**Re: GE-Pittsfield/Housatonic River Site  
Hill 78 Area-Remainder (GECD160)  
Addendum to Final RD/RA Work Plan**

By letter dated August 20, 2008, EPA conditionally approved the Final RD/RA Work Plan and required submittal of an Addendum to the Final RD/RA Work Plan within 30 days of the date of that letter (i.e., by September 19, 2008). In response to the conditions set forth in that letter, this *Addendum to Final RD/RA Work Plan* (Addendum) summarizes and addresses each of EPA's approval conditions and presents certain modifications to the Final RD/RA Work Plan. The soil-related Response Actions at Hill 78 Area-Remainder will be conducted in accordance with the Final RD/RA Work Plan, as modified by this Addendum.

**UTILITY CORRIDOR  
SOIL SAMPLE LOCATIONS**

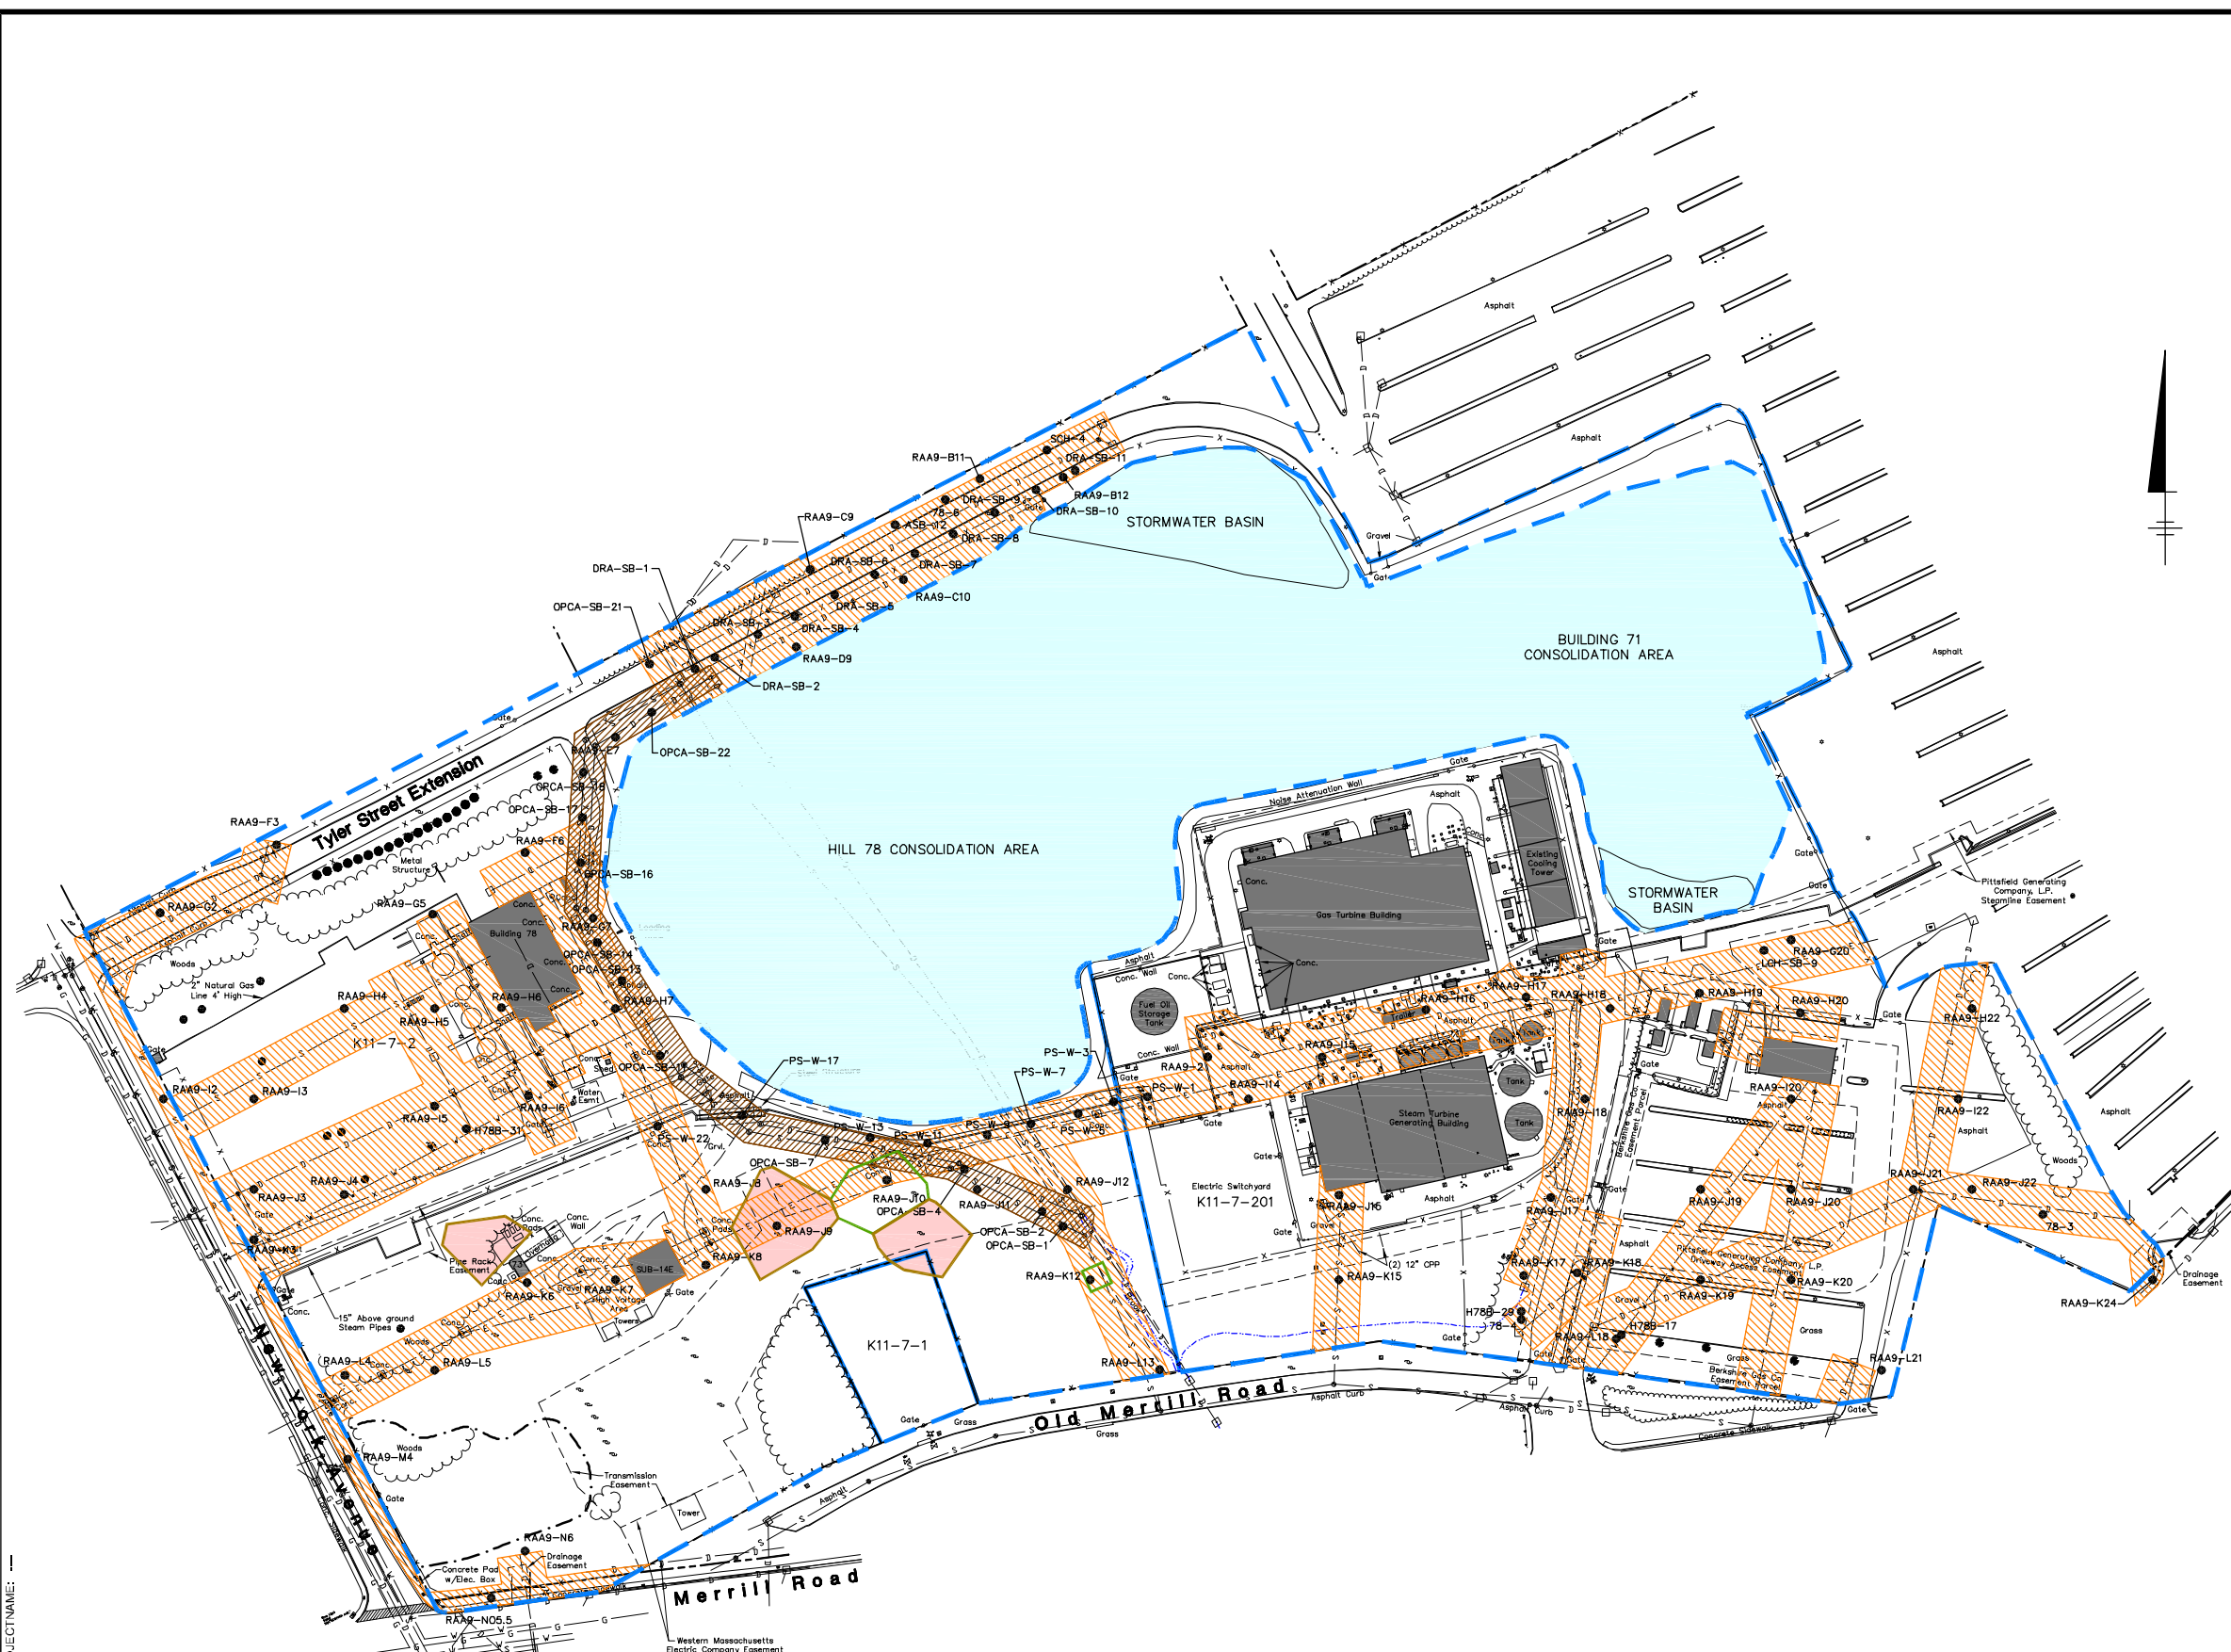
**EPA CONDITION 1:** *Section 5.2.2 of the Work Plan, Utility-Related PCB Information, indicates that GE performed an evaluation of the corridor associated with the re-routed storm and sanitary sewer lines and that the new pipeline corridor is shown on revised Figure B-33 and the PCB data collected from within the corridor are included on revised Table B-21. The revised Figure B-33 and Table B-21 included in Appendix A of the Work Plan do not include all of the soil sample locations and analytical results for 0 to 15 foot depth intervals within the new pipeline corridor. Specifically, sample location OPCA-SB-20, for which PCB results exist, is not included. GE shall revise Figure B-33 and Table B-21 to include all soil sample locations and analytical results used for evaluating utility corridors for PCBs.*

**EPA CONDITION 2:** *Figure B-33 also includes the boundaries of the Hill 78 and Building 71 OPCAs and associated stormwater basins. The OPCA boundaries depicted on Figure B-33 do not coincide with the boundaries depicted in Figure 1 of GE's July 27, 2007, Hill 78 Area-Remainder Third Supplemental Data Letter, Figure 3 of GE's April 13, 2006, Addendum to OPCA Work Plan or with the boundaries depicted in the Fourth Modification of the Consent Decree. GE shall revise Figure B-33 to include the correct OPCA boundaries and determine if any revised boundaries impact the soil evaluations for the RAA.*

**GE RESPONSE:** The soil sample location referenced in this condition (OPCA-SB-20) was not included in the in the evaluation of the utility corridor associated with the re-routed storm and sanitary sewer lines because it is not located within that utility corridor. As shown on Figure 4-1 of the Final RD/RA Work Plan, sample location OPCA-SB-20 is located within Tyler Street Extension, just outside the limits of the utility corridor for the re-routed sewer lines. Analytical data from OPCA-SB-20 was utilized in the evaluation of Parcel K11-7-2 (see Table B-2 of the Conceptual Work Plan). No other soil sample locations with analytical results for 0- to 15-foot depth intervals within the utility corridors that were not already presented on Figure B-33 and Table B-21 were identified.

Figure B-33 of the Final RD/RA Work Plan showed the same OPCA boundaries that were depicted in the EPA-approved Conceptual Work Plan, which incorporated the March 2006 detailed site survey and certain modifications to the Hill 78-Remainder/OPCA boundary to match the edge of the grading of the OPCAs (following modifications made to the OPCA limits that were discussed with and agreed upon by EPA). However, GE has now made the following changes to Figure B-33, and included a revised Figure B-33 in Attachment A to this document, for the reasons discussed below:

- *Area adjacent to the stormwater basin on the northern side of the Building 71 Consolidation Area.* Final RD/RA Work Plan Figure B-33 and Exhibit 1 of the Fourth Modification of the Consent Decree showed the boundary of the Building 71 OPCA going beyond the edge of the existing fence to the edge of the RAA. A review of the limits of the OPCA in this area shows that the boundary should follow the fence line in this area. The revised Figure B-33 presented herein illustrates the corrected boundary in this area.

- *Areas east and southwest of the stormwater basin on the south side of the Building 71 Consolidation Area.* Figure B-33 was revised to follow the boundary of the OPCA edge of grading and the southern storm water basin in this area, as shown on Figure 1 of the Phase III Final Cover letter.

- *Area to the west of the Hill 78 Consolidation Area.* Figure B-33 was updated to remove the loading dock which was previously shown to the east of the access road, as this structure was removed during the re-routing of the storm and sanitary sewer system pipelines. The OPCA boundary shown on revised Figure B-33 reflects the Final Cover Design as shown on Figure 1 of the Phase III Final Cover letter, and the boundary shown in Figure 2 of the Re-routing of Sanitary and Storm Sewer Pipelines.

- *Area between OPCAs and Pittsfield Generating Company Facility.* The boundary as shown in revised Figure B-33 reflects the proposed Phase II and Phase III Final Cover Boundaries of the OPCA as noted above. In general, along the south side of the OPCAs, the boundary follows the edge of the access road between the Hill 78 and Building 71 OPCAs and the Pittsfield Generating Company facility. That access road, which was not depicted on the figures referenced by EPA, has been added to revised Figure B-33. The OPCA boundary along that road was adjusted to extend to the edge of pavement at certain locations, particularly near corners of the road which were approximated on the prior figures.

GE has reviewed the soil analytical results and evaluations previously presented in the Conceptual and Final RD/RA Work Plans and has determined that these minor boundary modifications do not affect the soil evaluations or proposed Response Actions at this RAA. All soil analytical results near the modified boundaries are below the applicable Performance Standards and no additional soil data are needed to characterize the areas along this boundary. The only soil removal found to be necessary at this RAA was based on PCB results in the top foot in unpaved areas that contain PCB concentrations greater than 125 ppm -- the "not-to-exceed" (NTE) level -- at isolated soil sample locations that are not near the Hill 78 Area-Remainder/OPCA boundary. The soil polygons to be removed do not border the OPCAs, so no modifications to the removal limits are necessary.

GENERAL ELECTRIC COMPANY • PITTSFIELD, MASSACHUSETTS  
HILL 78 - REMAINDER ADDENDUM TO FINAL RD/RA WORK PLAN  
**PROPOSED DRAINAGE SWALE**  
GENERAL

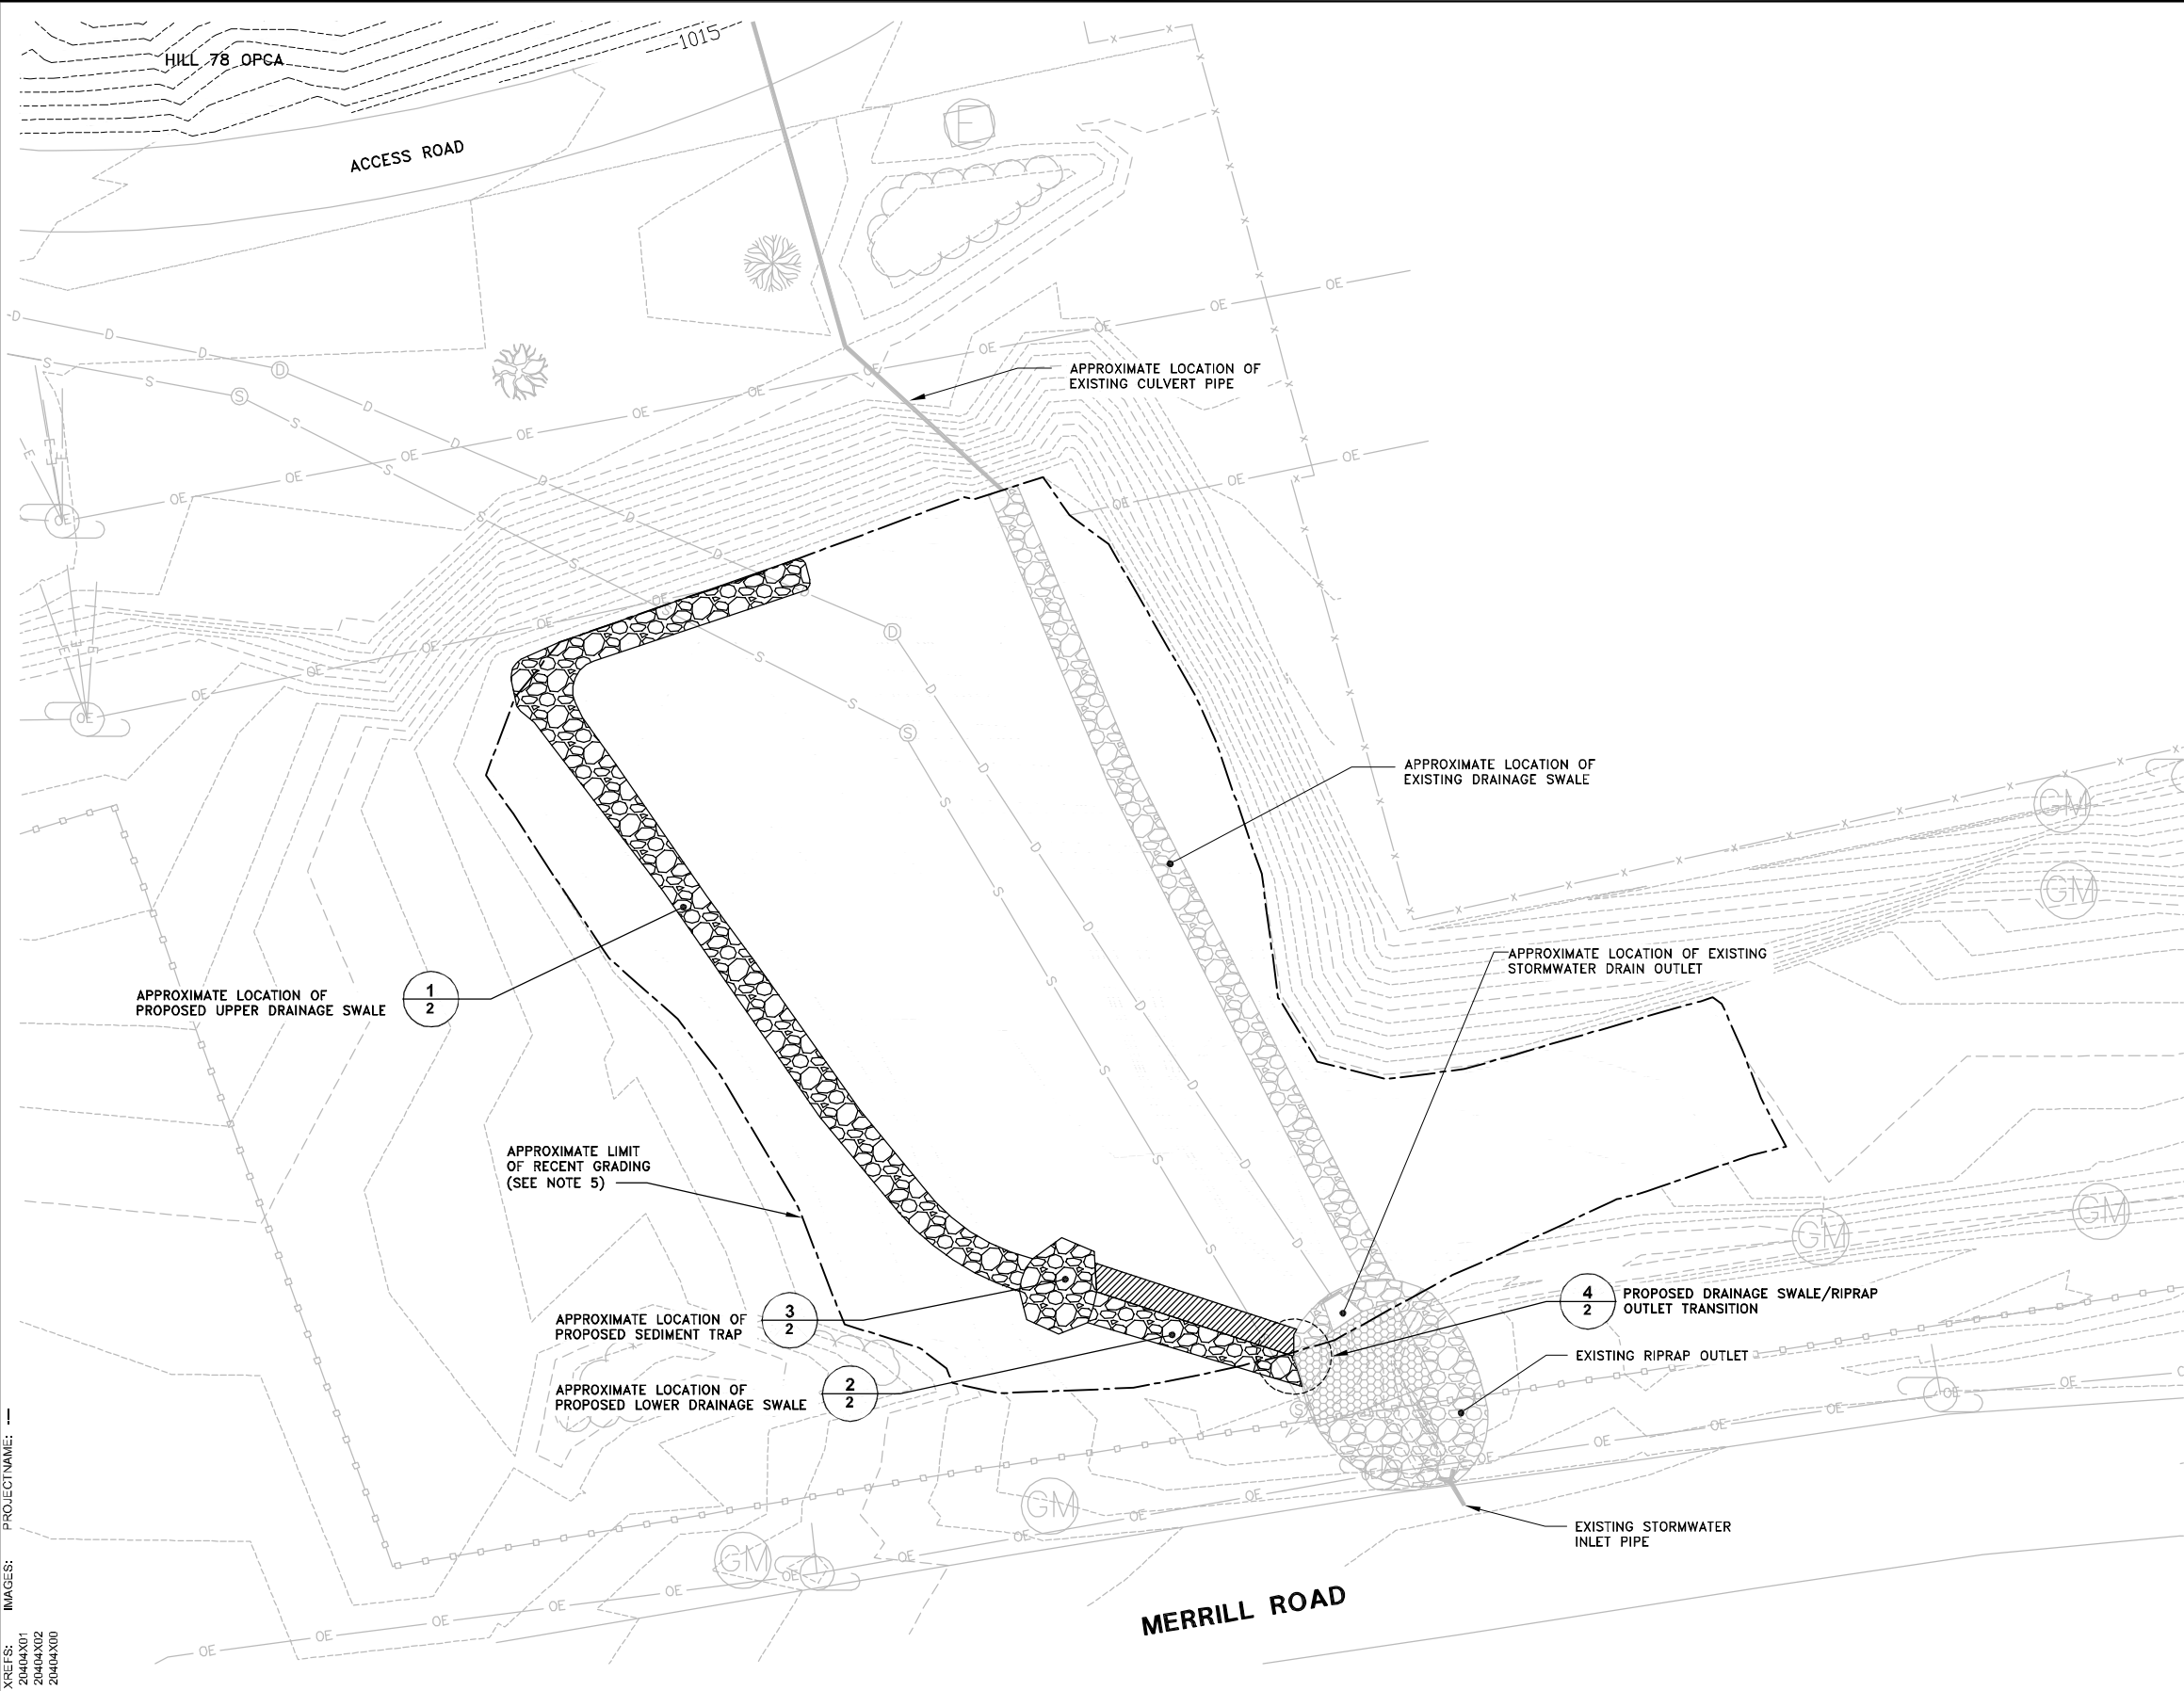
**EPA CONDITION 4:** *GE shall restore the areas impacted by the storm and sanitary sewer pipeline realignment activities prior to, or in conjunction with, the backfilling and restoration activities associated with the remediation described in the Work Plan. GE shall incorporate a restoration plan into the Post-Removal Site Control Plan for the Hill 78 Area-Remainder RAA which illustrates the locations of the new swales and other restoration components for the sewer pipeline realignment area, and documents the inspection activities to be performed.*

*Until restoration is complete, GE shall top soil and seed the area at the southern end of the realigned sewer that has not been addressed since completion of the construction of the sewer, or shall implement interim measures to address erosion occurring at the southern end of the realigned sewer. These measures shall include, but are not limited to, the installation of silt fences and hay bales along the mid-slope of the exposed area, along both sides of the existing drainage swale, and surrounding the edge of the swale at the opening of the storm sewer.*

**GE RESPONSE:** As shown on Drawing Nos. 1 and 2 (provided as Attachment B to this letter), GE is proposing to construct a riprap drainage swale (proposed swale) south of the Hill 78 OPCA. The proposed swale will be located west of an existing riprap drainage swale (existing swale). The existing swale conveys stormwater received from a culvert pipe and from areas adjacent to the swale. The existing swale drains into a riprap outlet located immediately north of Merrill Road. The riprap outlet, which receives stormwater drainage from the existing swale as well as the recently relocated 48-inch storm sewer pipe, discharges to an existing culvert which flows south beneath Merrill Road.

The proposed drainage swale will be constructed to manage stormwater runoff from upgradient areas, including areas that were re-graded during sewer relocation activities. The proposed swale will commence along the toe of the slope south of the Hill 78 OPCA access road and will convey stormwater south to the existing riprap outlet. The proposed swale, which will include a stone check dam, will be configured as shown on Drawing No. 2 (Attachment B).
